MEMO

TO: Steven Kleppin, Director of Planning and Zoning, City of Norwalk, CT
FROM: Stewart Gordon, PE, PTOE and William Melendez, PE, PTOE, PTP
SUBJECT: Traffic Engineering Peer Review of 10 Norden Place (Norden Park)
DATE: December 7, 2020

GENERAL OVERVIEW

Figure 1 - Loading Docks- South side

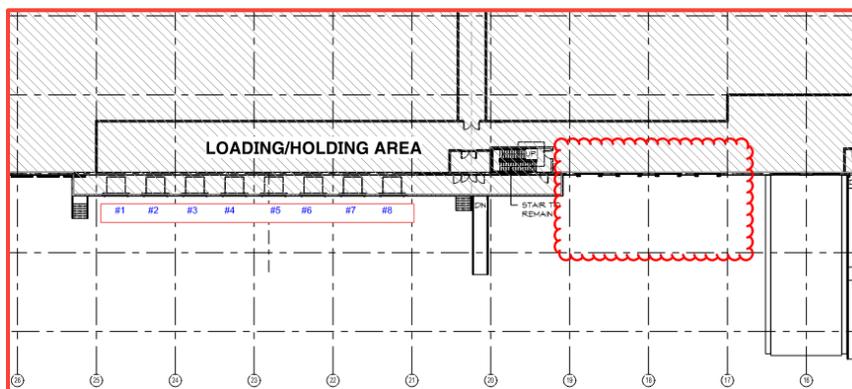
3. *Loading Docks - The supplemental materials indicated that the number of loading docks have been modified and that there will be a total of 19 loading docks. However, the plan sheet A2 shows eight loading docks in the north side and eight loading docks in the south side. The applicant should identify the location of the remaining three loading docks.*

WSP finds the applicant's responses acceptable, however, the applicant did not provide an updated A2 plan sheet showing the location of the remaining three loading docks. The applicant should confirm if the additional three loading docks are located as shown in the following figure.

- Loading Docks – The applicant should confirm that the additional three loading docks located in the south side are shown on Figure 1 of this document.

The applicant confirmed that there will be 19 loading docks, eight in the north side and eleven in the south side.
